NUMBER 83

BULLETIN

SUBJECT: Tailskid Spring Attachment Reinforcement

MODELS AFFECTED: E2 and J2

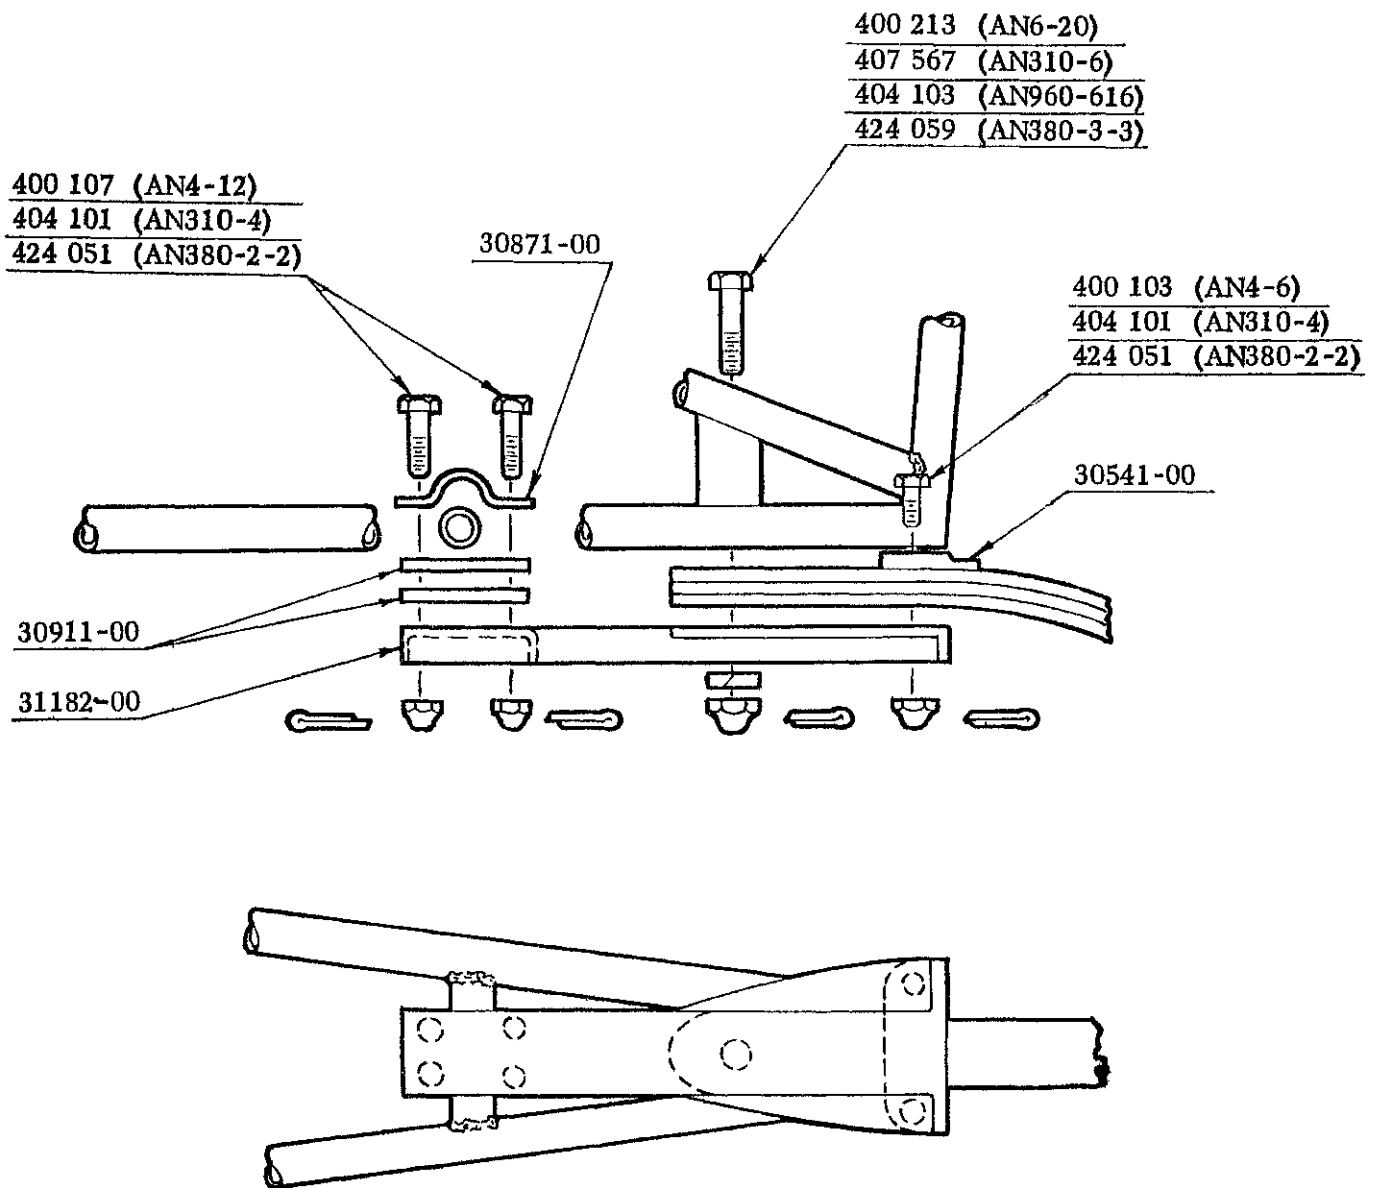
We have received a number of reports of failure of the tailspring attachment on the subject model airplanes, and at the suggestion of the Civil Aeronautics Administration, we have developed a reinforcing unit, part numbers 30882 and 30871, which may be bolted to the tailspring and fuselage structure. (See Sketch).

If your airplane is subject to hard landings, incident to student training, or if you are operating from a rough field, we recommend that this reinforcement be installed to prevent any possible failure of the tailspring attachment.

These parts may be obtained through your local dealer or distributor and, when installed, should be covered by an appropriate entry in the aircraft log book.
